Building Conservation comments

File Ref: 23/00407/FP & 23/00408/LBC

Address: Node Court, Drivers End Lane, Codicote, Hitchin, Hertfordshire SG4 8TR

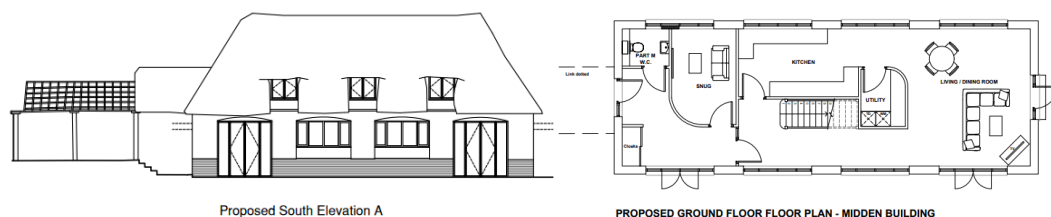
With regard to Flats 3 and 6, I once again, suggested that the proposed spiral staircase is replaced with a more conventional staircase and that this could be located in the position of the proposed kitchen i.e. stairs/hallway immediately behind the front door. The WC could also be located alongside the staircase. Once again Briffa Phillips pushed back on this suggestion on the basis that this reconfiguration results in a number of unsuccessful spaces such as a poor layout to the kitchen as the window sills here are lower than kitchen counter heights, the underside of the

staircase will be visible in the main bedroom, the loss of a separate study room and a cramped smaller bathroom.

Whilst the proposed layout would not occasion harm to the heritage asset, I remain of the view that the staircase options I have suggested previously would work better.
